UNITED STATES PATENT AND TRADEMARK OFFICE

| 09/883,851 | 06/18/2001 | Bogdan C. Maglich | HIENER.1CPC1CP | 9955 |

| Office Action Summary | Application No. | Applicant(s) | |

Figure 8. Layout of the API laboratory at STL.

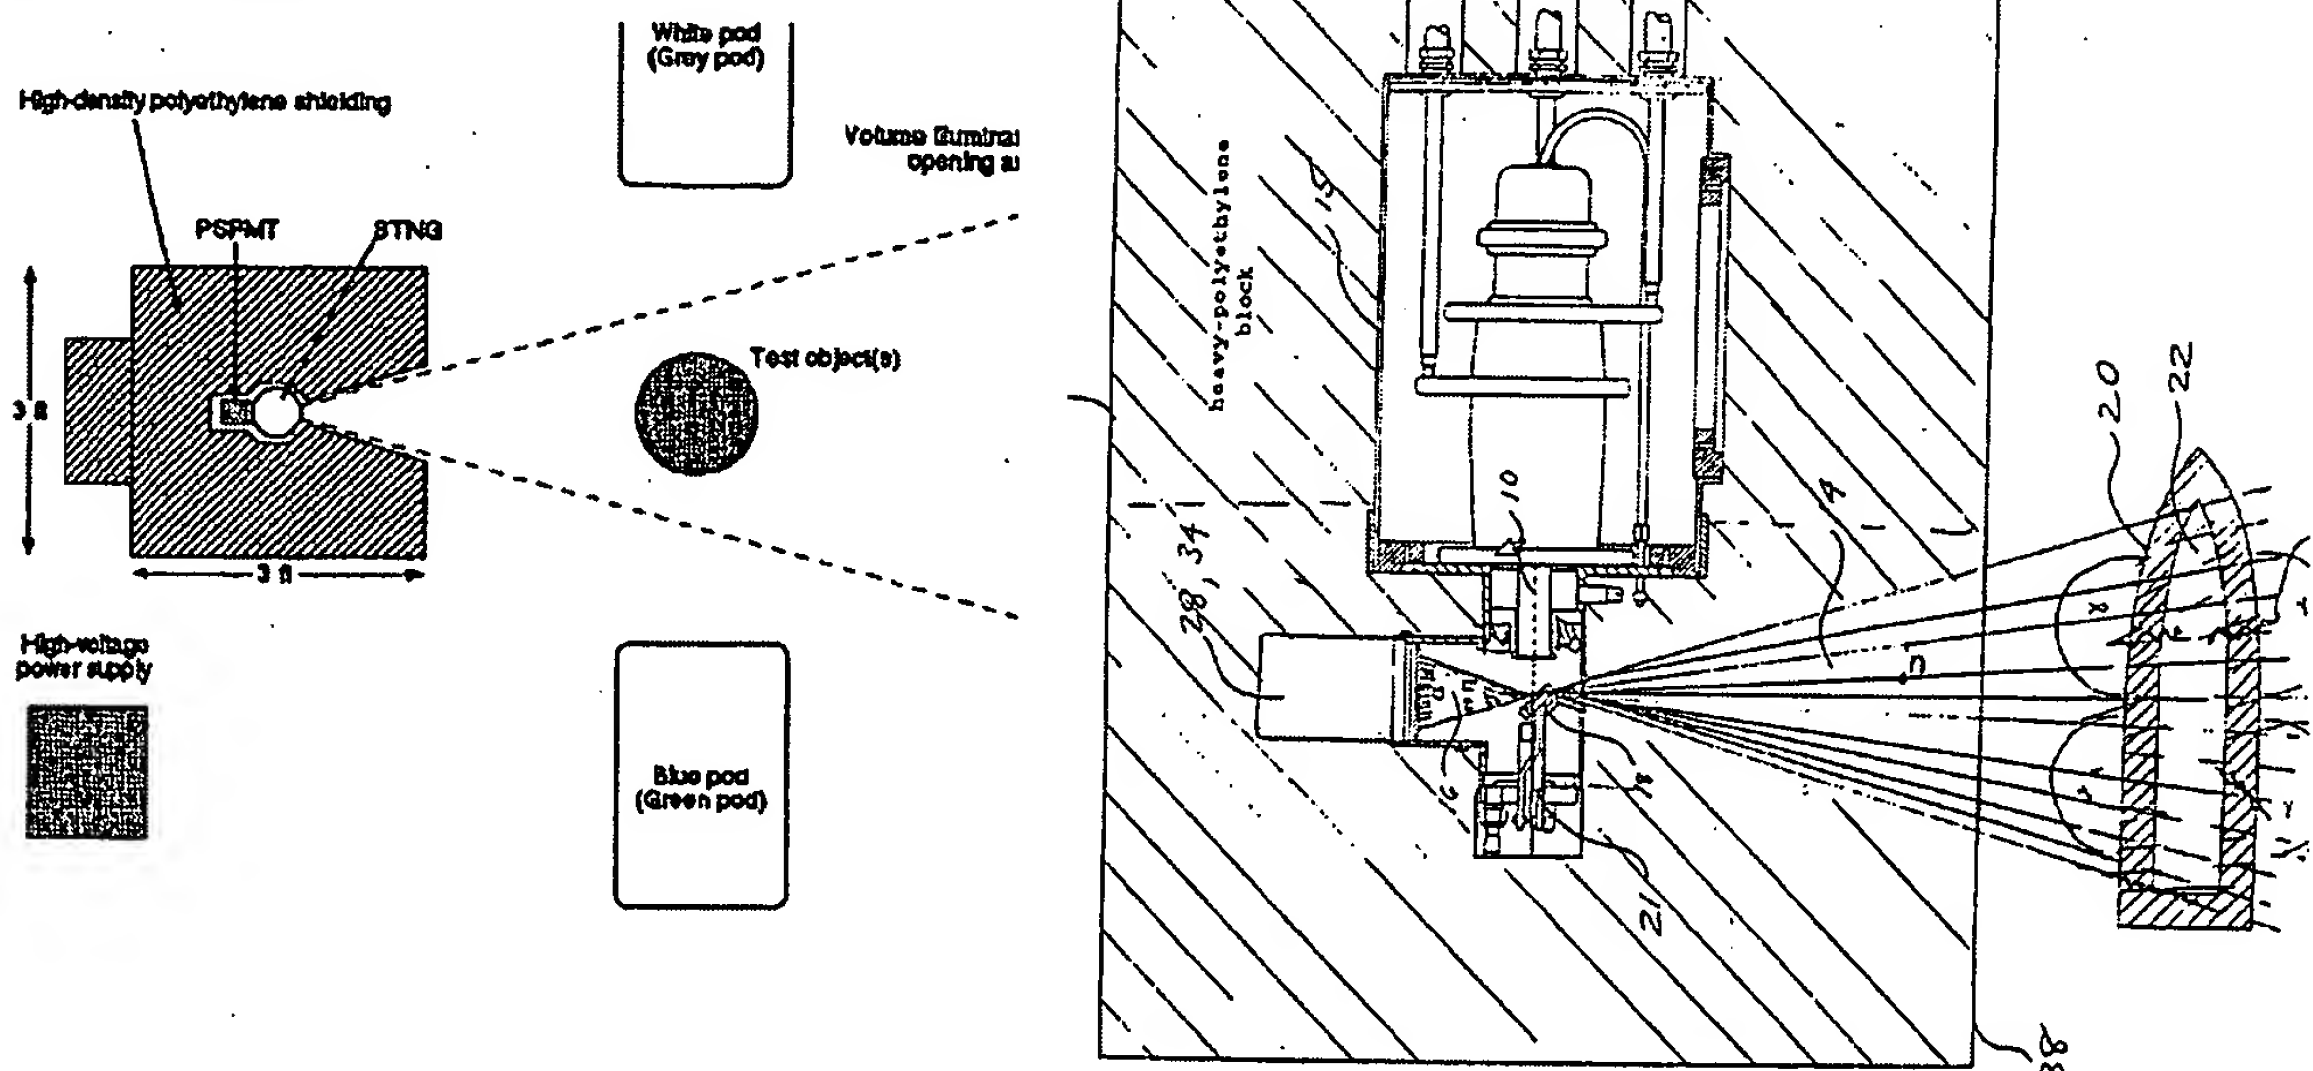
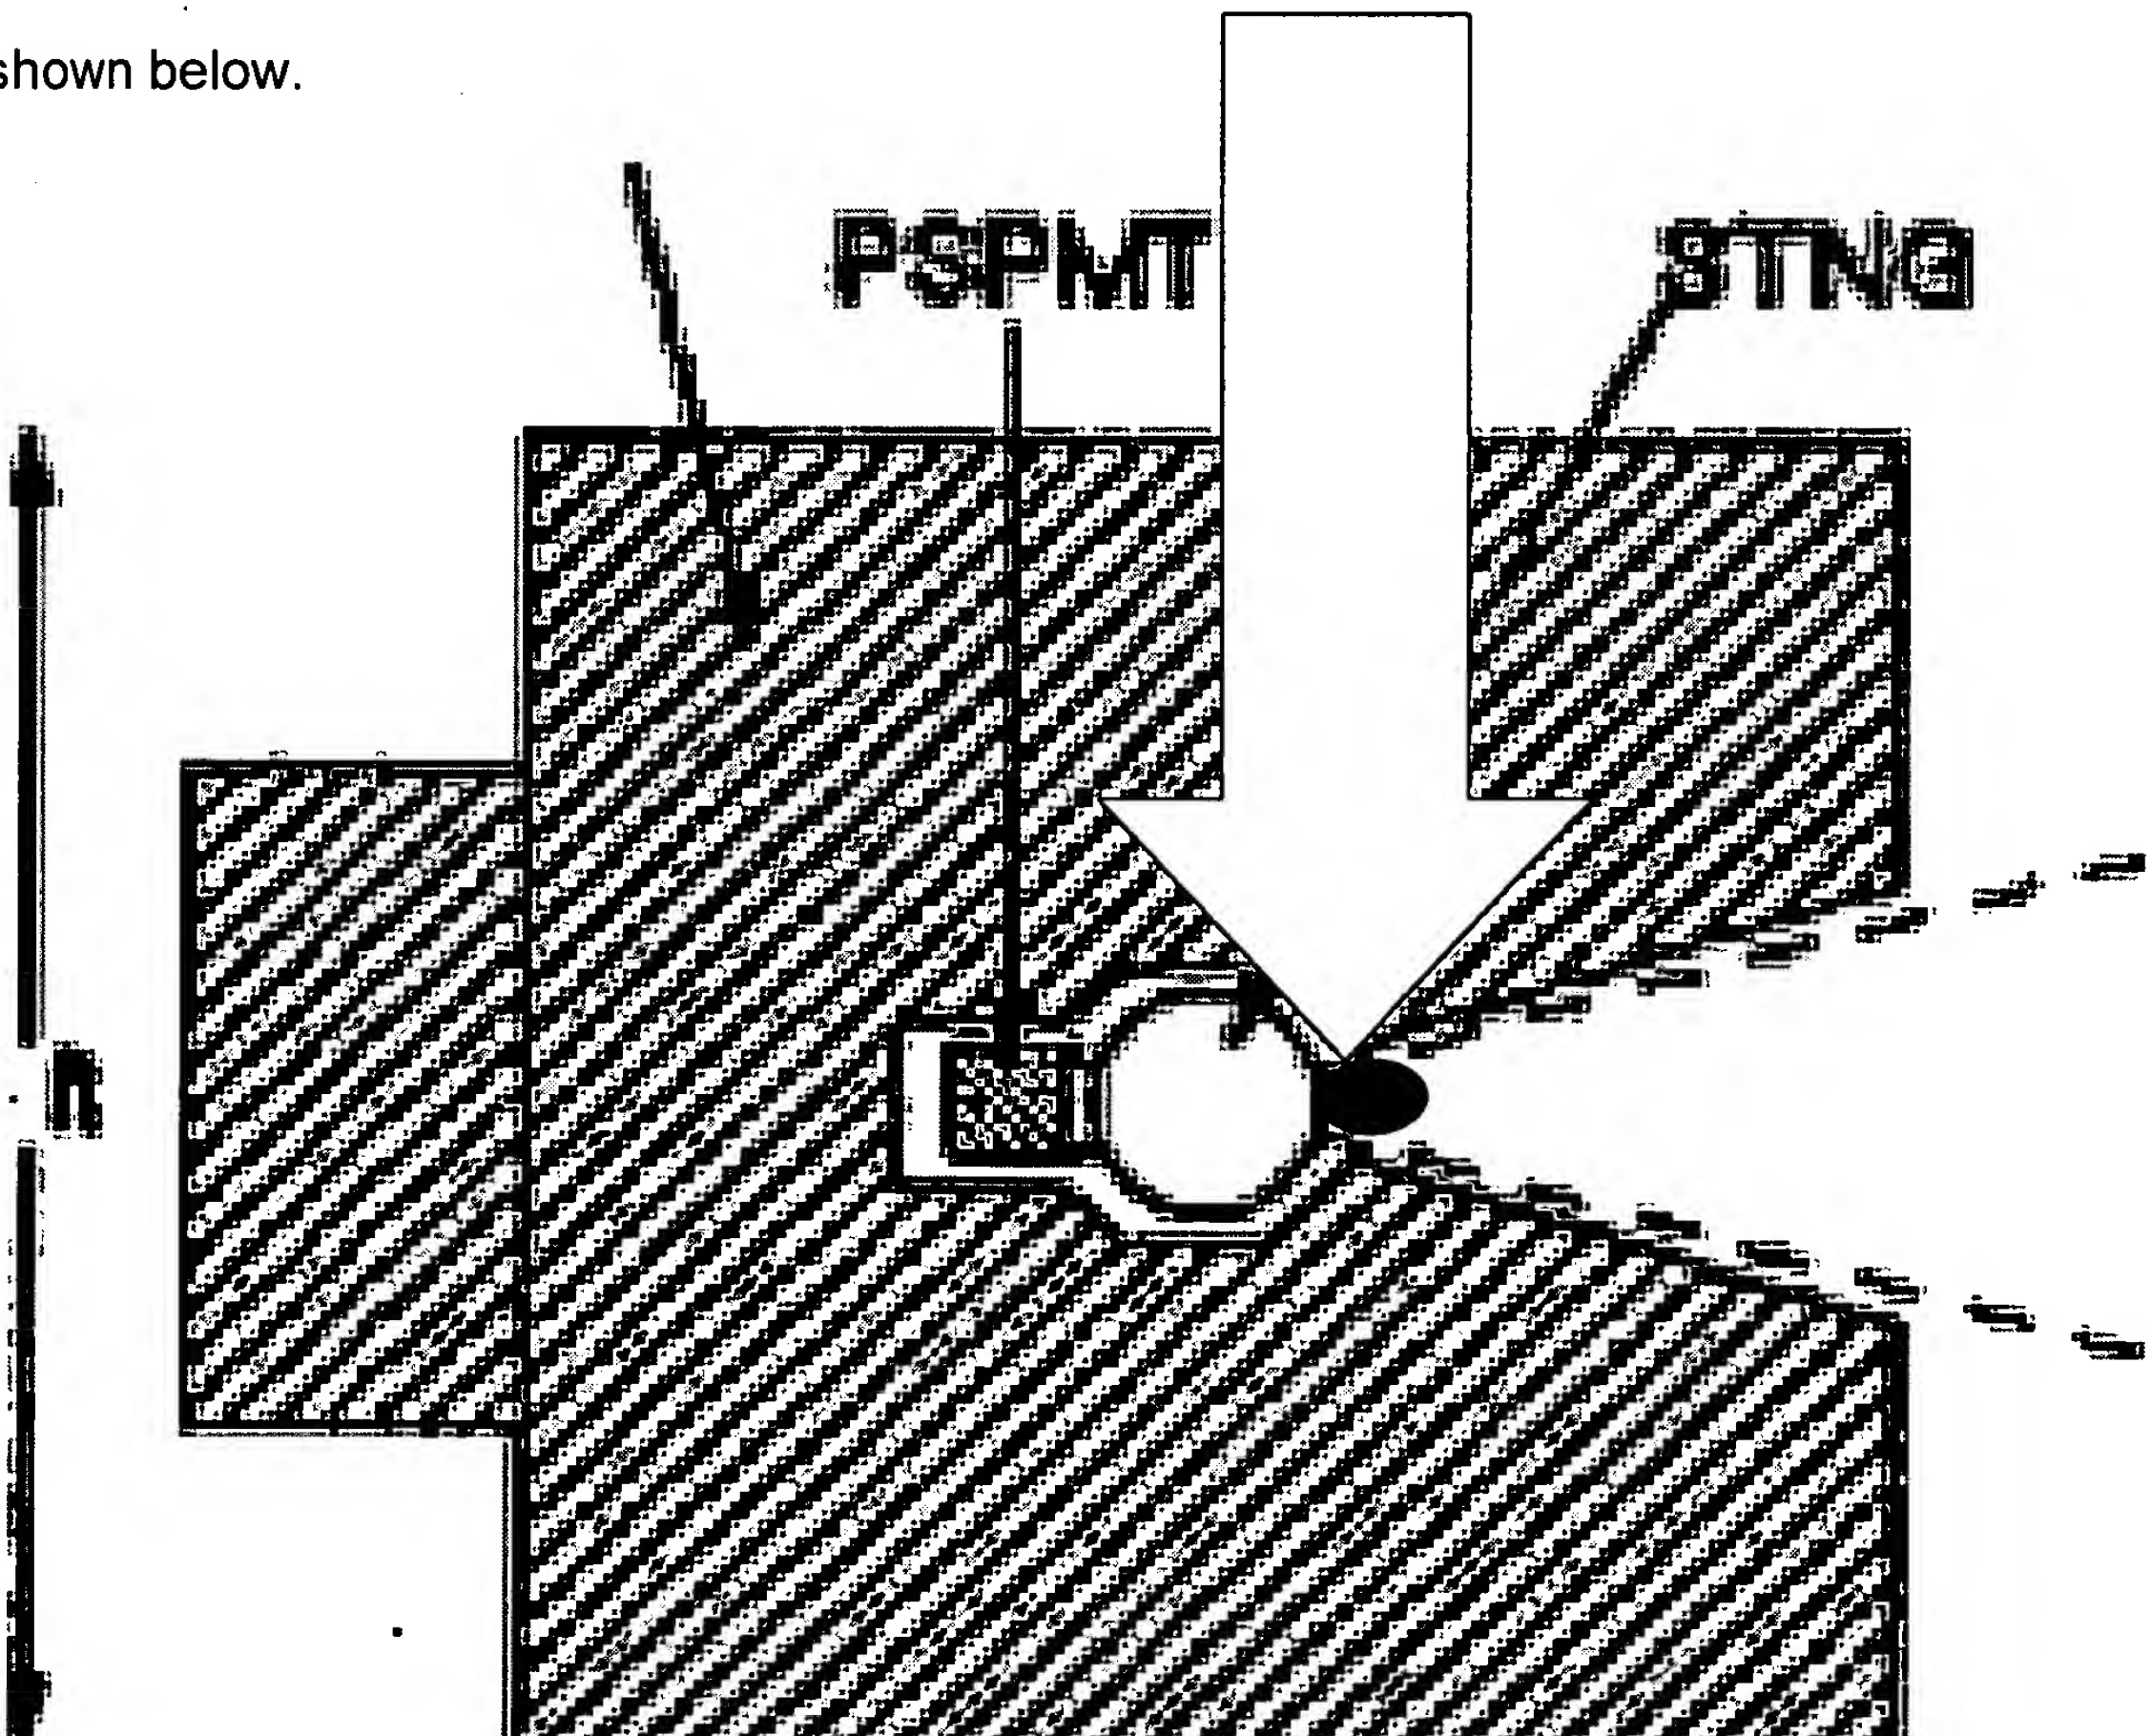
RESPONSE: Applicant appears to be singling out one figure of the Bechtel reference in order to support his position of the argument. However it is considered that applicant himself has the same issues with his own invention. For example, a comparison of figure 8 of the Bechtel reference and Figure 1 of Applicants own invention is shown below. Note how they both have polyethylene shielding.

There is no reason why the target material of Figure 8 cannot be located in the same position as claimed in applicants claim 1 by merely moving the target closer as shown below.

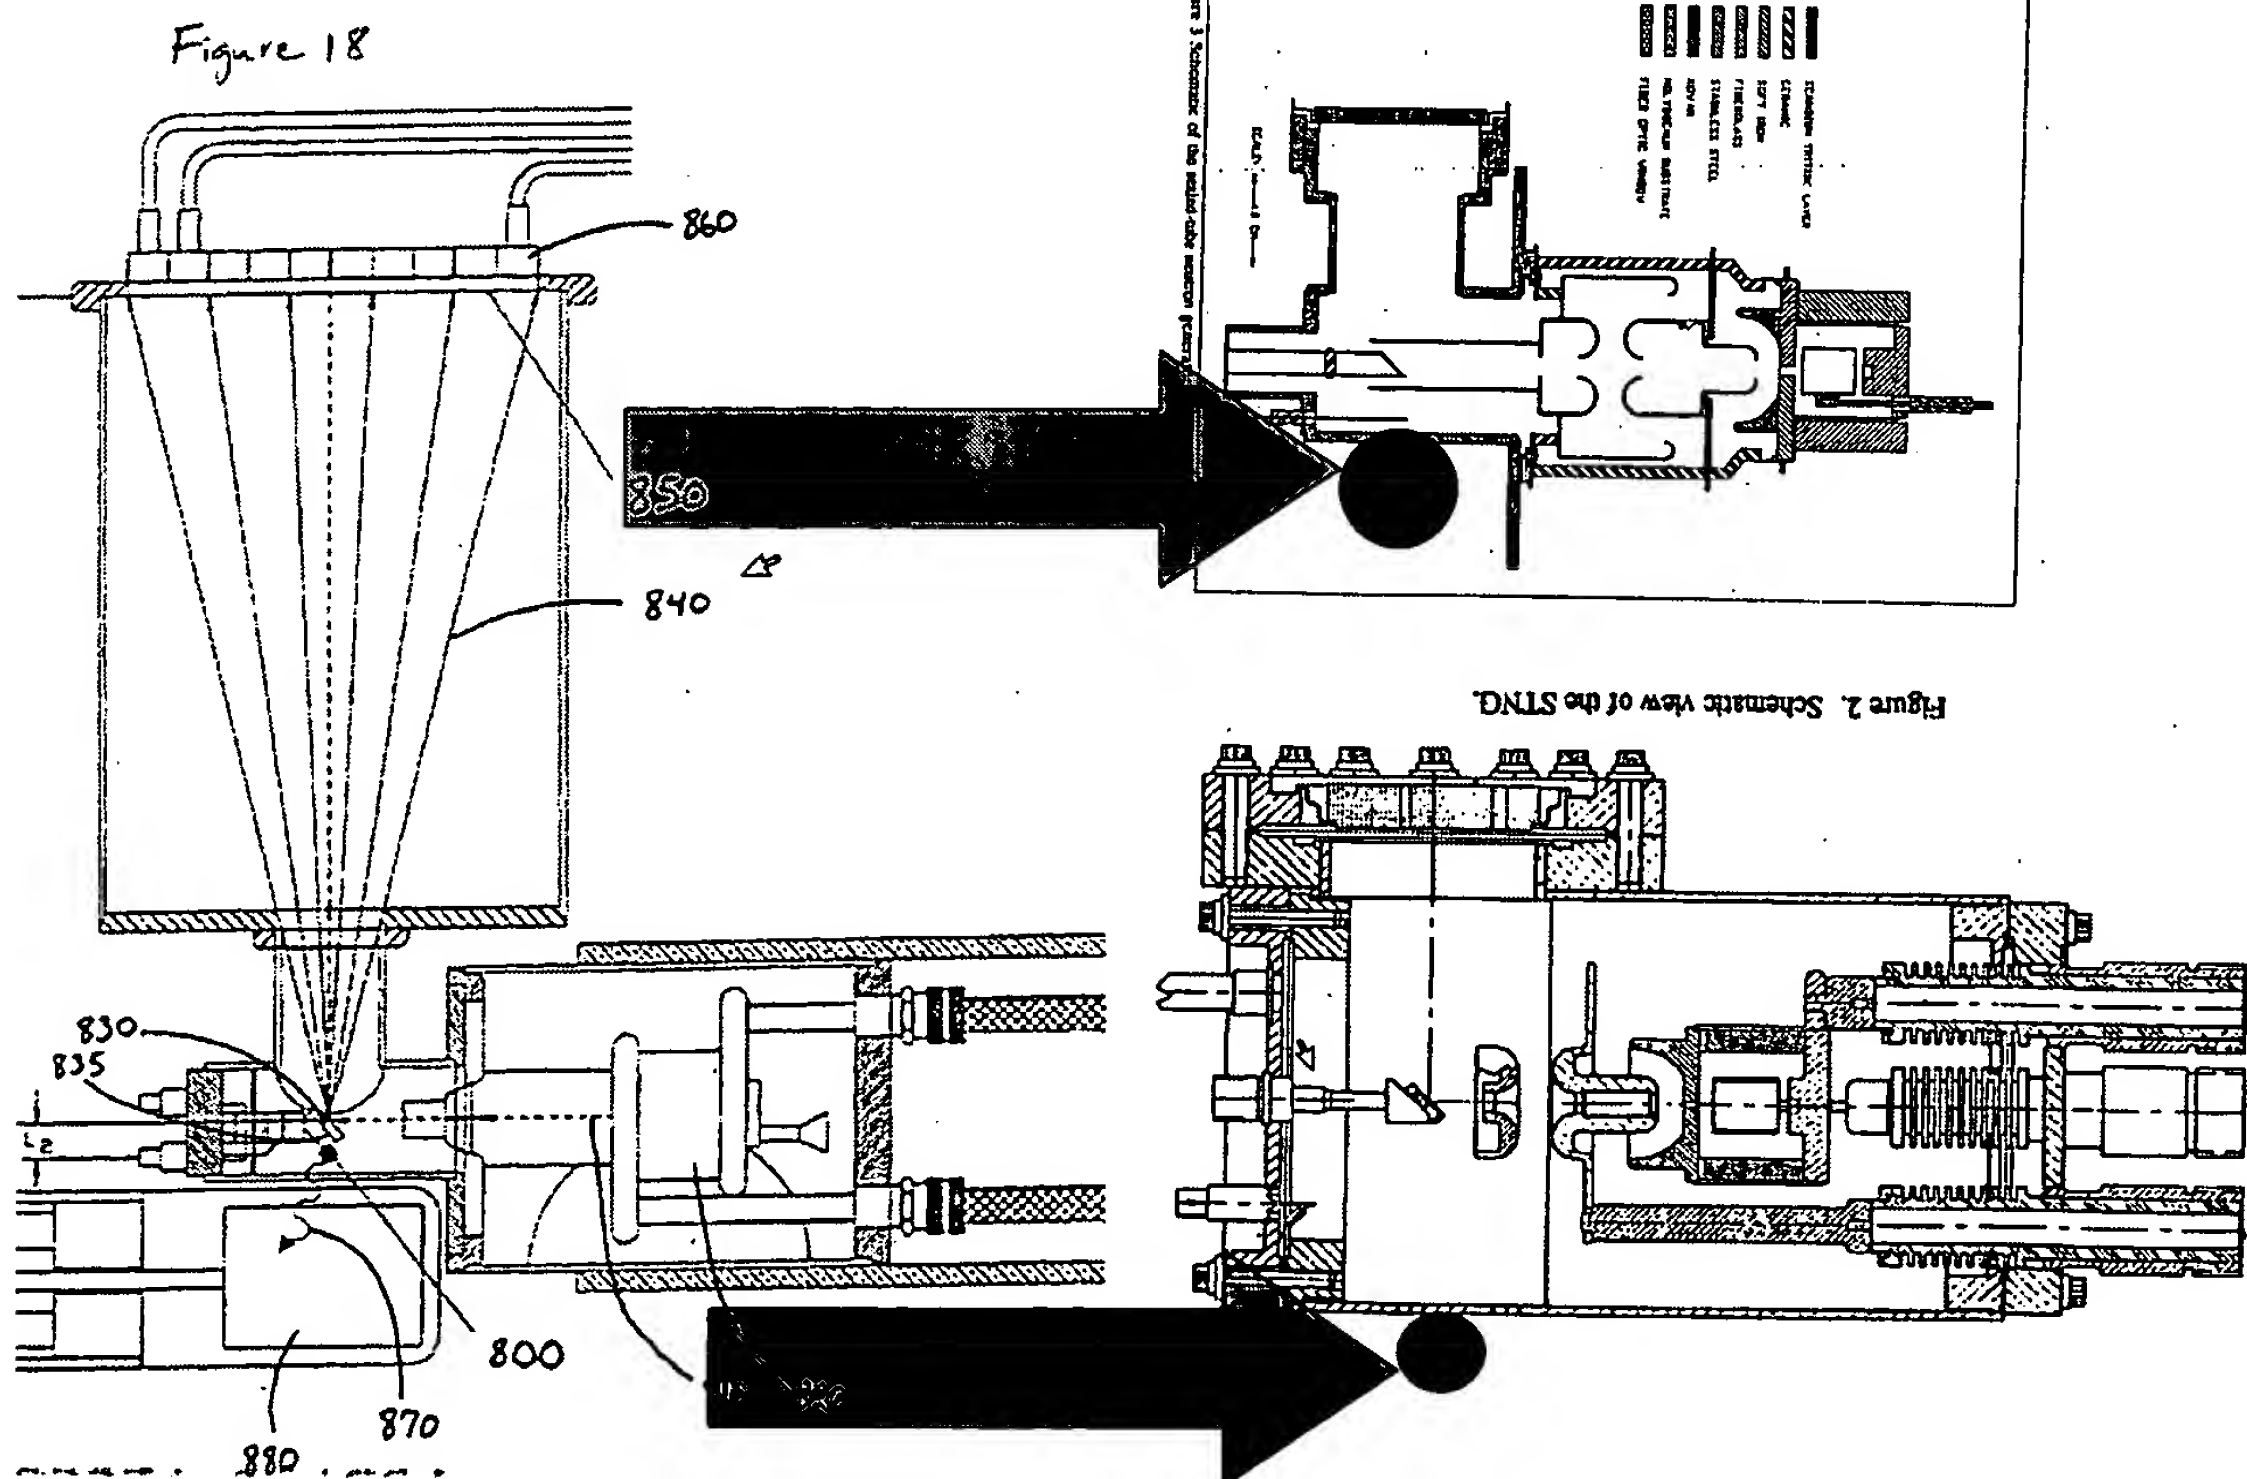
For another way to explain how the reference is inherently capable of being situated as applicant claims, let's turn to Figure 18 of Applicant's invention, Figure 2 of the Bechtel reference and figure 3 of the Hurley reference (Current Status of the Associated Particle Imaging system at STL, 1992) (both of which have been rotated to allow ease of viewing corresponding features. Note that the Bechtel reference is a later report of the Hurley reference and as such the figures are considered synonymous and/or interchangeable as representations of the inventions disclosed therein. Clearly, if the black dots shown below are the material to be analyzed, then the distance between the target material and particle detector array is indeed larger than the distance between the target position and the material to be analyzed.

Again, the Bechtel reference is indeed inherently capable of being positioned as claimed.
